ARBORIST REPORT

Tree Inventory, Tree Descriptions and Recommendations Relative to Proposed Construction

Winchester Boulevard Office

Winchester Boulevard at Shelburne Way, Los Gatos

C EXISTING TREE PROTECTIVE FENCING
SCALE: 1/4" = 1'-0"

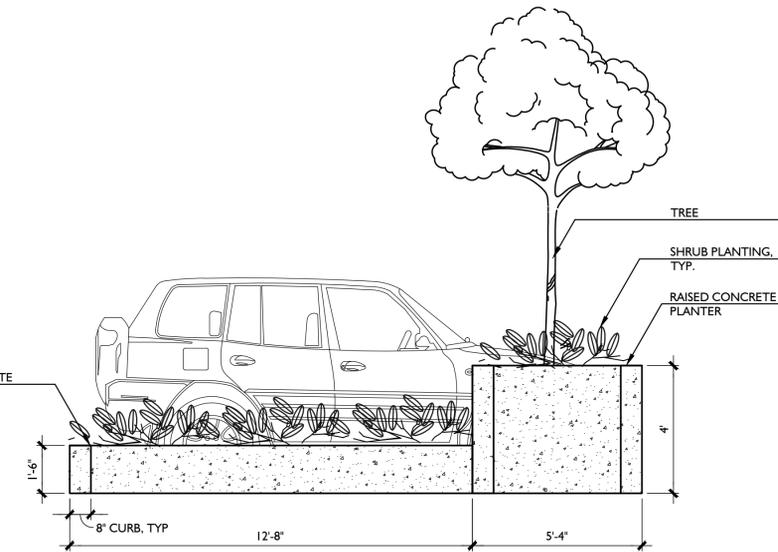
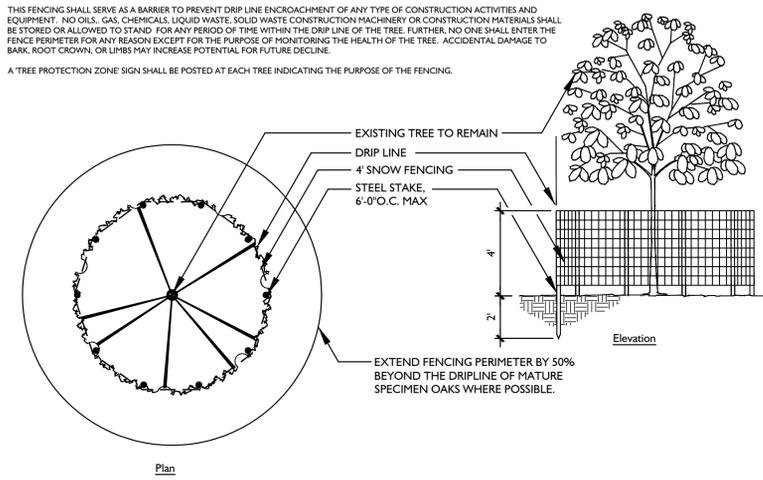
- Tree Protection Fence Detail, Sheet L-4: remove this. Replace with Town of Los Gatos Tree Protection Directions.
